LETTER WITH ATTACHED CHANGE PAGES REGARDING WORK PLAN FOR
GROUNDWATER REMEDIATION AT SITE 11 NSB KINGS BAY GA
9/14/2001
NSB KINGS BAY

RE: Contract No. N62467-98-D-0995
Contract Task Order No. 0047 – Naval Submarine Base (NSB) Kings Bay, Georgia
Response to Georgia Department of Natural Resources, Environmental Protection
Division Comments on the Work Plan No. 02 for Groundwater Remediation at Site
11, Old Camden County Landfill

Work Plan No. 02
Groundwater Remediation at Site 11
Old Camden County Landfill

Figure 1-3
Groundwater Containment Plume Isopleth Map
NSB Kings Bay, Georgia

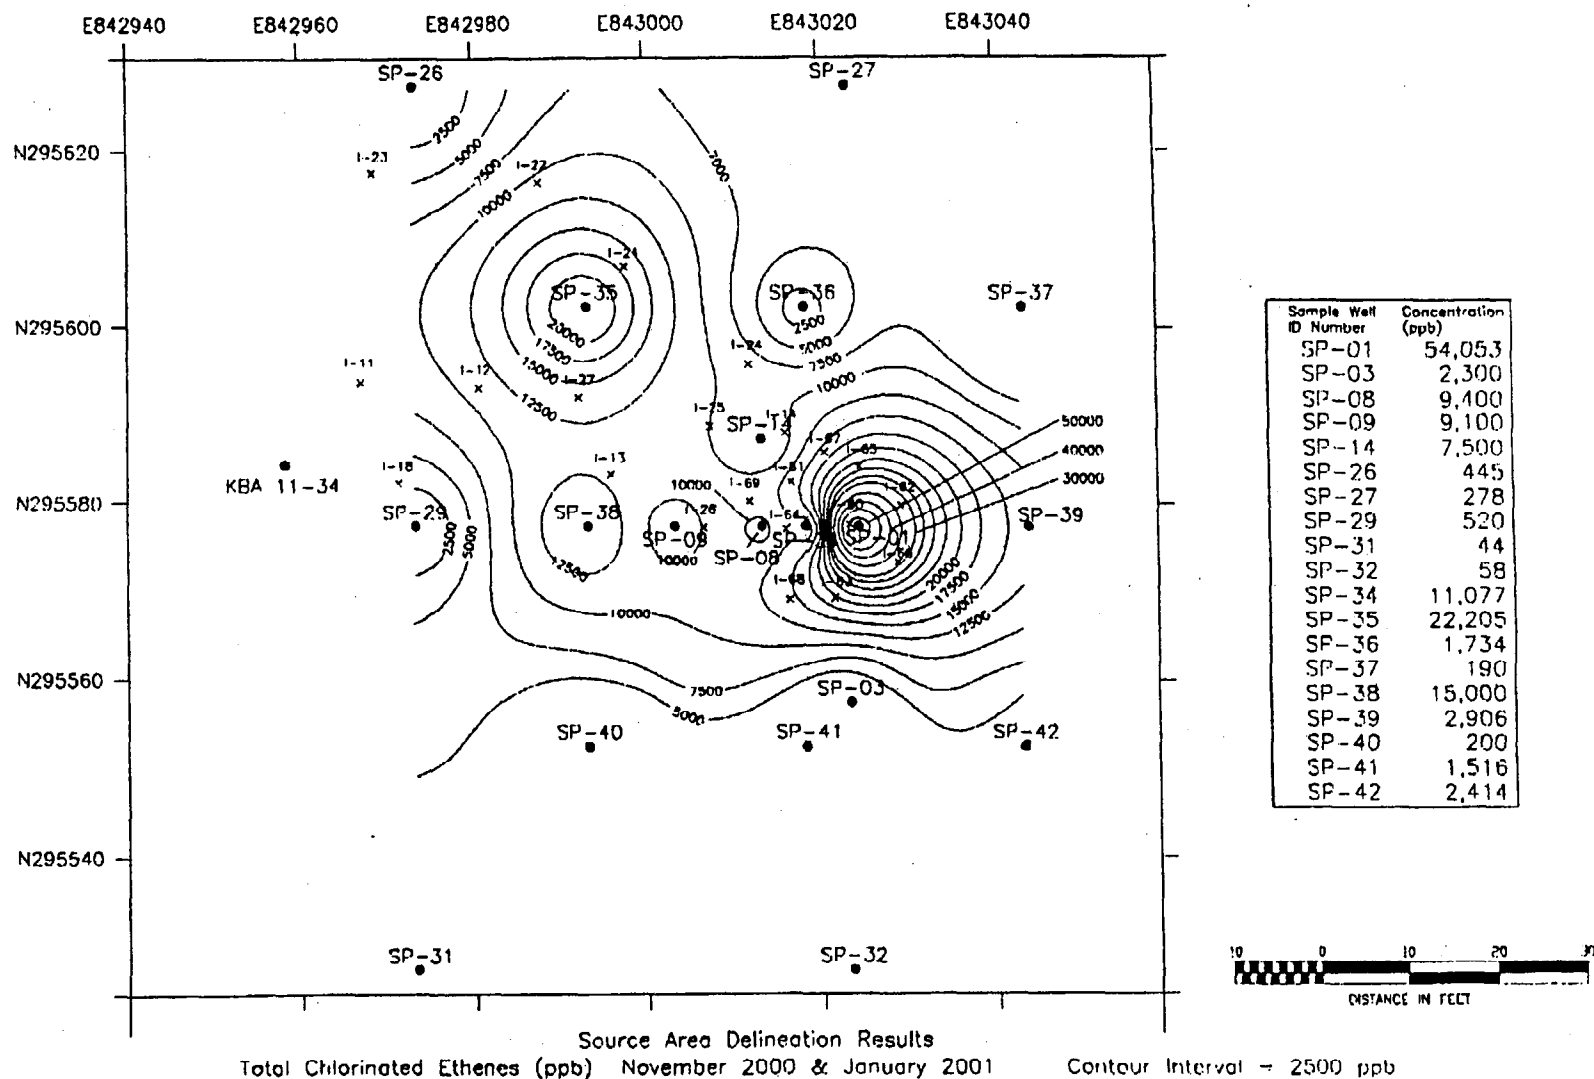
Comment No. 01: Section 1, Figure 1-3: This Figure is misleading and possibly erroneous in several aspects, including the following:

- a. The "zero" concentration isopleth has nonzero data outside its bounds.
- b. The isopleth indicated as "32,000" and the unmarked 18,000 isopleth near SP-35 have no data points within to support the conclusion that these are closed contours.
- c. The 10,000, 12,000, and 14,000 isopleths between SP-03 and SP-37 intercept.

Response No. 01: Figure 1-3 has been revised and the replacement page is enclosed.
